**Proposed North Carolina Amendments to 2020 NEC
Prepared by Electrical Adhoc Committee – July 7, 2020**

Item 0: Retaining Existing NC Electrical Code Amendment, Article 10 with the modification of section 10.1 and addition of section 10.10

Figure 410.2 Exception Clothes Closet Storage Space Exception

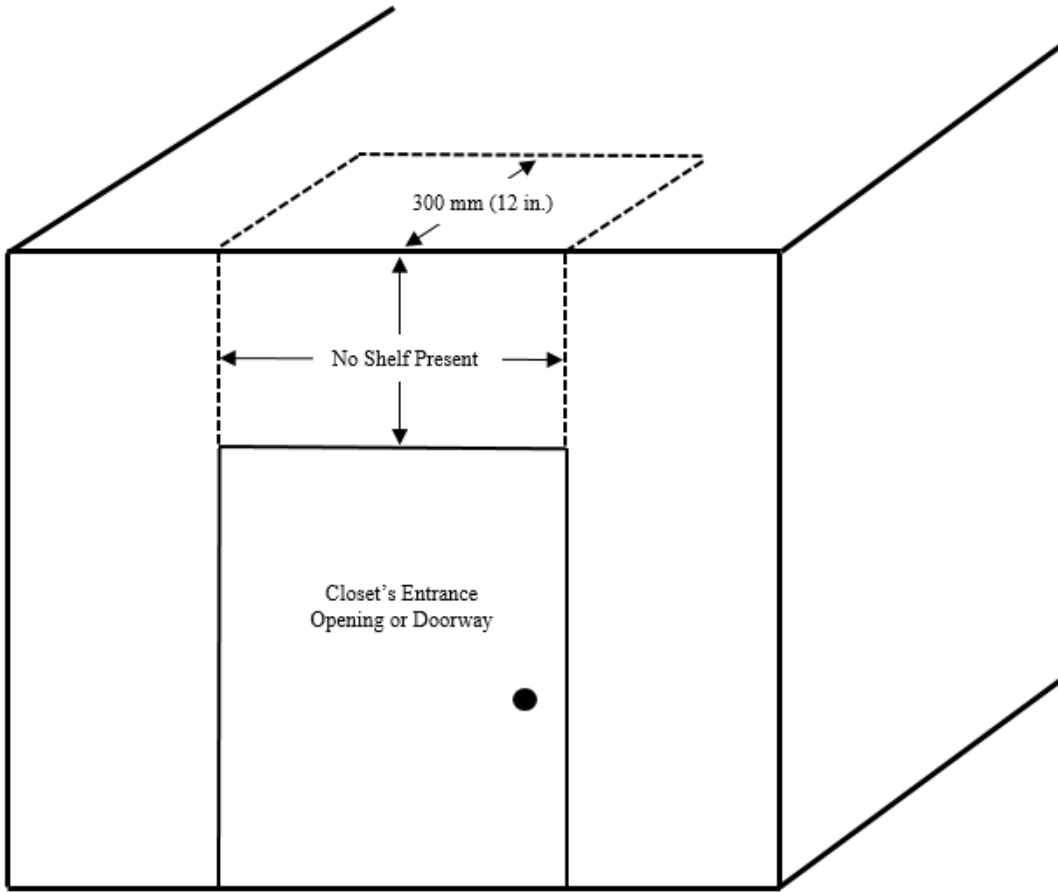
Exception: Where a shelf is not present in the area of wall above the closet's entrance opening or doorway extending from the top of such opening or doorway vertically to the ceiling, including the area of ceiling extending perpendicular from the area of wall directly above the closet's entrance opening or doorway to a horizontal distance of 300 mm (12 in.), shall not be defined as closet storage space. See Figure 410.2 Exception.
